SERVICE BULLETIN
Factory of Alcalá Spain

REPLACEMENT OF WASHING GROUP

PREVIOUS			NEW

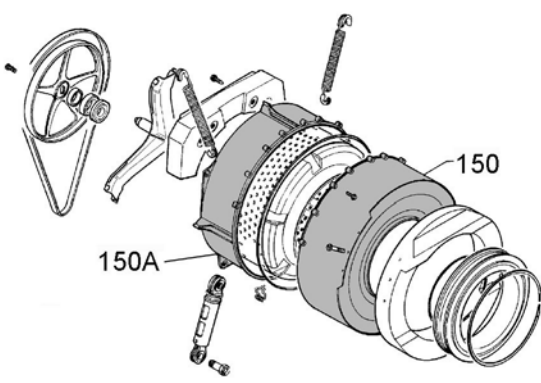
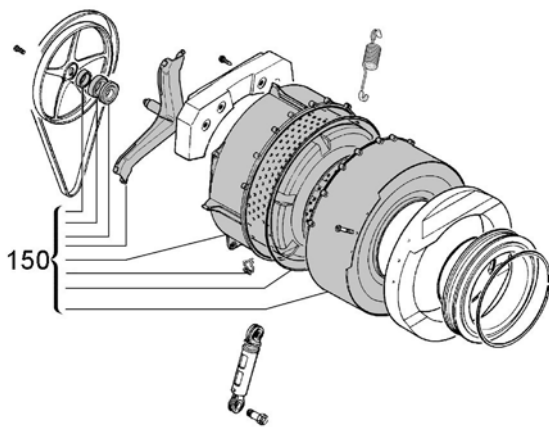
We inform you that the rear and front shell of the screwed washing groups are not available anymore as spare parts.
The welded shell assembly is delivered as a replacement and can be mounted in place of the screwed one.

Pos.	Description	Part no.	Pos.	Description	Part no.
150	Shell, front, tub	Out of stock	150	Sealed tub assembly	126 85 72-30/0
150A	Shell, rear, tub	Out of stock
